Sicherheitsmitteilung SM051102

Betreff: ADVANCE – Gurtzeuge
Gebrochene Naht vom Brustgurt und zu lose Hand-Deploy Tasche.

Subject: Addendum of S.B. n° 051101 from 3/11/05

Old conception

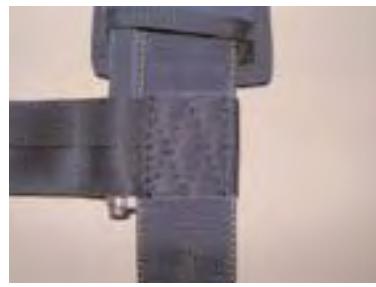
We have seen that the method of conception of the chest strap can be made in a better way. This method will avoid any fall of the user from the harness in such situation. We are suggesting to make a complete confluent wrap with the chest strap webbing around the left main webbing. (right picture) instead having just a part of the webbing around it (left picture). By this way in case of seams failure the chest strap webbing will remain to protect the user of any falling possibility. Elasticity differences between type 7 and type 8 webbing and this type of conception used are not the best method in such dissymmetrical stress and hard opening. Seams cannot resist in such situation because stiches cannot be as elastic as the webbing is.

It is evident that this kind of separation of the chest strap from the main lift webbing can happen to any kind of conception which doesn't integrate a complete confluent wrap around the MLW. The conception we used and those who consist to insert the chest strap between the MLW (even if it is stronger) do not protect at all the user from a falling possibility from its harness in case of such violent opening and stress transfer to the chest strap.

We are asking to have all Advance harness-container equiped with a type 8 chest strap which not used a confluent wrap to be return for modification to our factory. This modification can also be done into a certified rigging loft. This modification is mandatory and it is totally free of charge for the customer.
